REPORT TO THE HEARING EXAMINER

HEARING DATE:	October 13, 2015
Project Name:	Dohrn Meadows Preliminary Plat
Owners:	Natalie Dohrn & John Wade; 2205 W 136 th St; Broomfield CO 80023; and Gregg Dohrn; 2129 S Rockwood Blvd; Spokane WA 99203
Applicant/Contact:	Joe Pruss; Civic Development; 18211 240 th Ave SE; Maple Valley WA 98038
Contact:	Chad Allen; Encompass Eng.; 165 NE Juniper St, Suite 201; Issaquah WA 98027
File Number:	LUA14-001280, ECF, PP
Project Manager:	Kris Sorensen, Associate Planner

Project Summary: The applicant is requesting Hearing Examiner Preliminary Plat review and Environmental (SEPA) review for a 9-lot single family residential subdivision. The 89,819 square foot (2.06-acre) site is a combination of two parcels located at 3815 and 3767 Monterey PI NE (APNs 3345700181 and 3345700182) within the Residential-8 (R-8) zone and Kennydale Community Planning Area. Proposed single-family lot sizes range from approximately 5,201 square feet to 8,270 square feet. Two existing single family homes, one on each parcel, would be demolished. Approximately 15,028 square feet is proposed to be dedicated public streets. Two tracts are proposed, one for the subdivision stormwater

GENERALIZED UTILITY PLAN

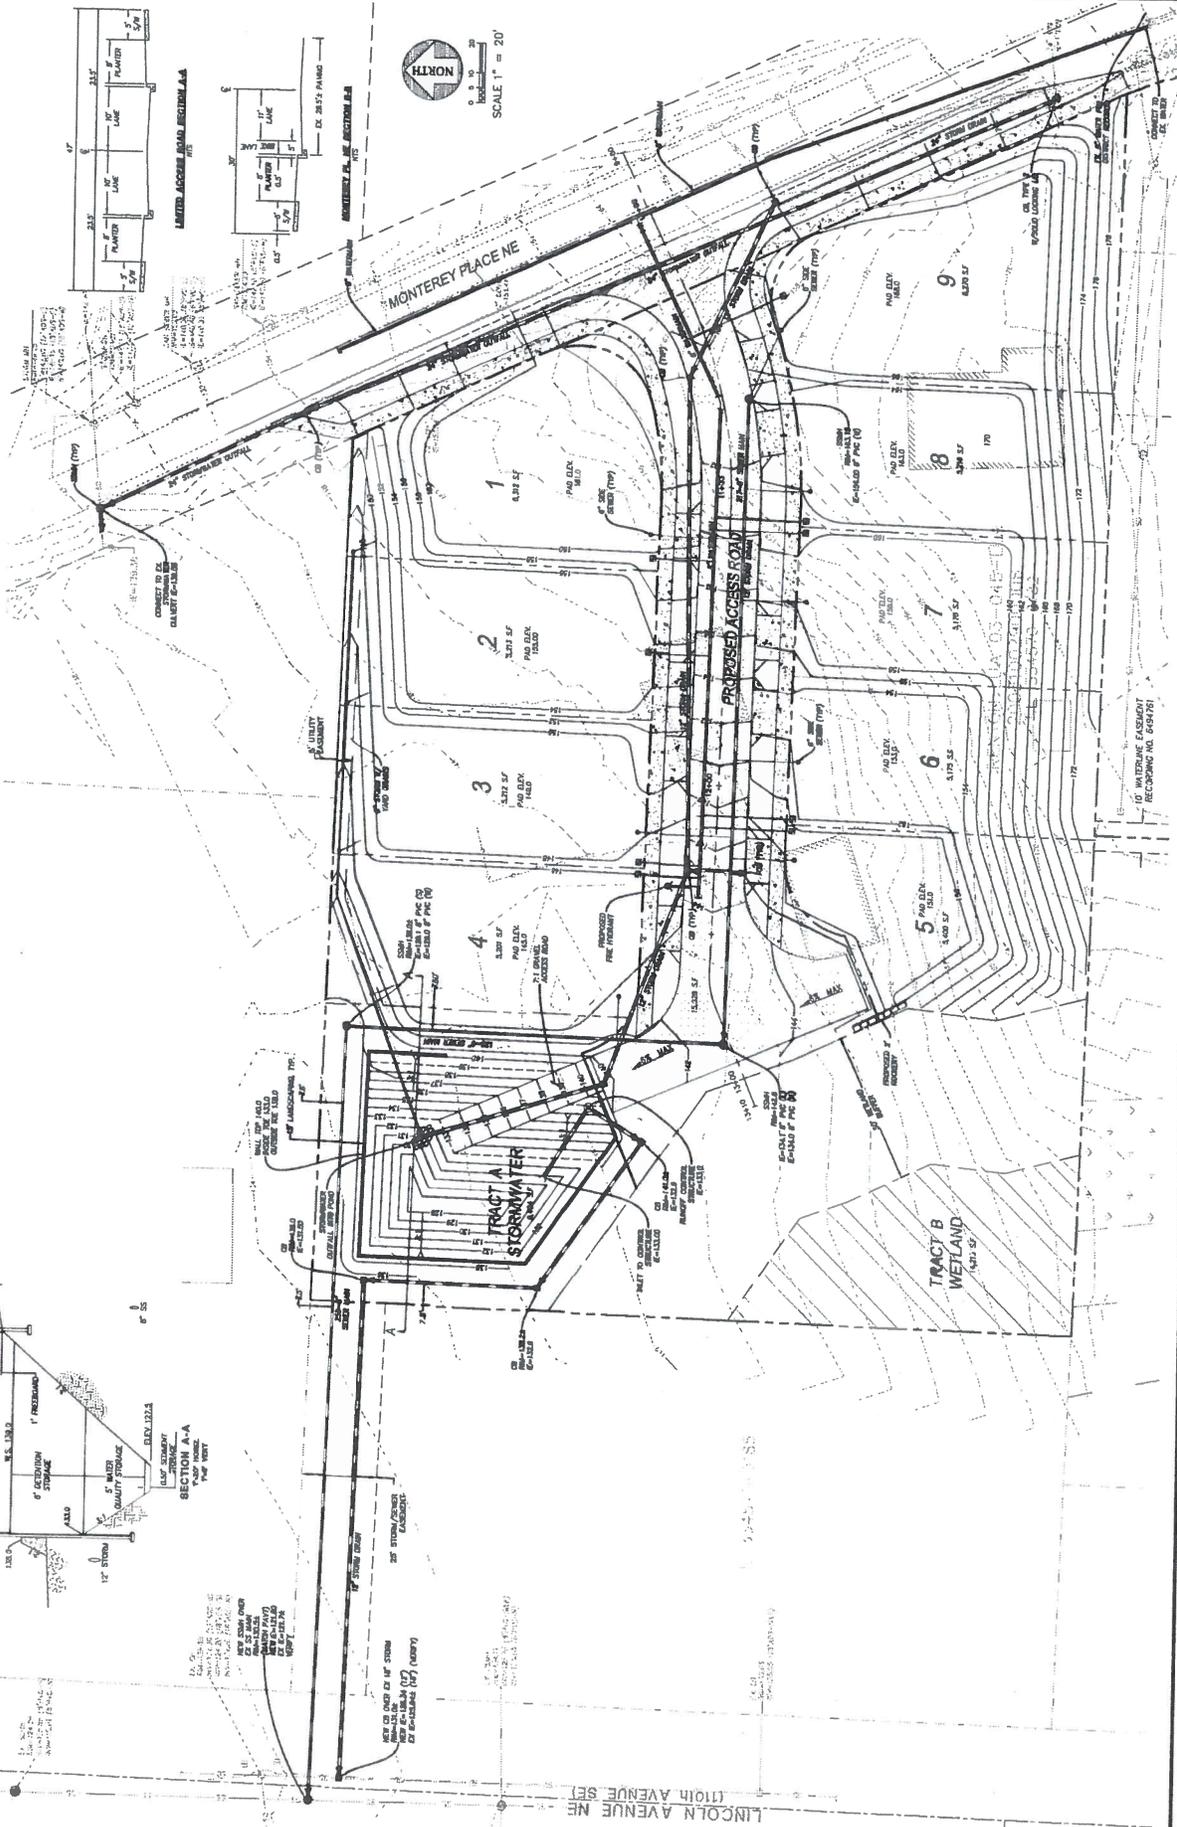
<p>height and proposed vegetation would create a screening of the open pond from neighboring properties. The exterior wall of the storm water pond is identified on Exhibit 7 ("Section A-A") where approximately 4 feet of the exterior wall on the westerly side would be above the proposed grade, with the first 2 feet covered by a slope and the upper 2 feet not covered. On the opposite easterly side, the top of the wall of the storm water pond would be approximately at grade plane with the ground. A 15-foot wide landscape perimeter is proposed around the pond, to provide planting area for a vegetated screening of those portions of the pond wall that extend above the surrounding grade plan. To provide an obscuring landscape visual buffer, staff recommends, as a condition of approval, that the landscape buffer around the stormwater pond walls be screened by a "Fully Sight-obscuring Landscaped Visual Buffer" per RMC 4-4-070H that is required to be a minimum 6-foot high screening at plant maturity and one hundred percent sight obscuring.</p>

Impacts: A drainage plan and revised preliminary drainage report prepared by Encompass Engineering was for the project (Exhibit 7 and 10). Based on the City's flow control map, this site falls within the Flow Control Duration Standard, Forested Condition. A combined detention / water quality pond is proposed to meet the detention and water quality needs of the project within a tract in the northwest corner of the site (Exhibit 4). The proposed facility will be a public storm water facility with a connection through an easement on the westerly abutting property with a connection to City storm facilities within Lincoln Ave NE.
